# Access Compliance Report

## Public Rights-of-Way

Intersection ID: 18932	Main Street: GLENHAM_DR	Cross Street: TYVOLA_RD	Location: NE
ADA ID: 81B3CABCB2A5	Ramp Type: PerpDiag	Initial Pass/Fail: Fail	Overall Compliance: No
		Severity Score: 12.5

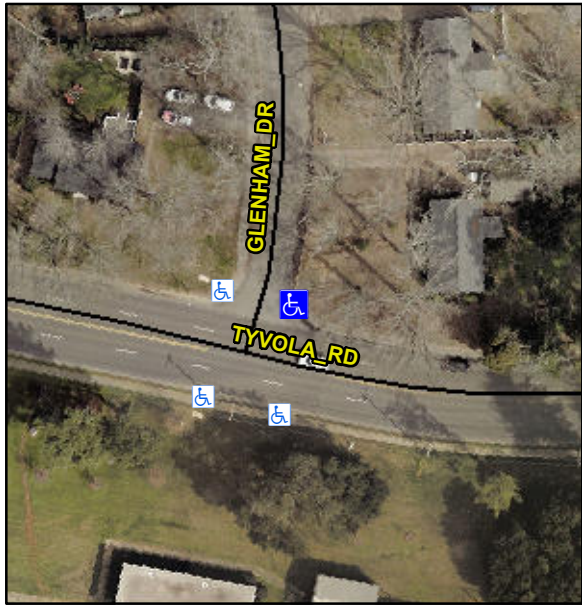
Codes/Mitigation Info/Possible Solution		Field Measurements/Component Compliance							
	Possible Solutions:			<b>Compliance</b>	<b>Description</b>	<b>Data</b>	<b>Compliance</b>	<b>Description</b>	<b>Data</b>
	<b>Remove &amp; Replace Curb Ramp With Two New Directional Ramps or Equivalent.</b>			N/A	Ramp Length (in)	53.0	No	Ramp Slope (%)	10.0
				Yes	Ramp Width (in)	100.0	Yes	Ramp XSlope (%)	1.8
				N/A	Flare Type LT	N/A	N/A	Flare Type RT	N/A
			N/A	Flare Slope LT (%)	N/A	N/A	Flare Slope RT (%)	N/A	
			N/A	Flare Traversable LT?	N/A	N/A	Flare Traversable RT?	N/A	
			N/A	Landing Length (in)	N/A	N/A	DWS Provided?	N/A	
			N/A	Landing Width (in)	N/A	N/A	DWS Contrast?	N/A	
			N/A	Landing Slope (%)	N/A	N/A	DWS Length (in)	N/A	
			N/A	Landing X Slope (%)	N/A	N/A	DWS Full Width?	N/A	
		N/A	Landing Curb? (Y/N)	N/A	N/A	DWS Offset (in)	N/A		
<p>Surveyor Notes:</p> <p>N/A</p>	PROW/ADA:			N/A	Shared Landing?	N/A

N/A	Gutter Ponding?	N/A	N/A	Gutter Slope (%)	N/A
				N/A	Gutter Lip Ht (in)	N/A	N/A	Gutter X Slope (%)	N/A
				N/A	Painted X Walk1?	No	N/A	Painted X Walk2?	No
					X Walk 1 Direction	To NW		X Walk 2 Direction	To SW
				N/A	X Walk 1 Width (in)	N/A	N/A	X Walk 2 Width (in)	N/A
					X Walk 1 Slope (%)	4.5		X Walk 2 Slope (%)	2.6
					X Walk 1 X Slope (%)	3.4		X Walk 2 X Slope (%)	2.4
				N/A	Ramp inside XWalk1?	N/A	N/A	Ramp inside XWalk2?	N/A
					Road Slope (%)	1.4	N/A	Clear Space?	N/A
<p>Total Cost:</p> <p>\$ 3200.00</p>					Road X Slope (%)	5.7	N/A	Clear Space to XWalk (in)	N/A
				N/A	Any Obstructions?	N/A	N/A	Storm Grate/Utility Hazard?	N/A
					Obstruction Type			Storm Grate/Utility Type	
						N/A			N/A
							Yes	Surface Condition? (G/P)	Good
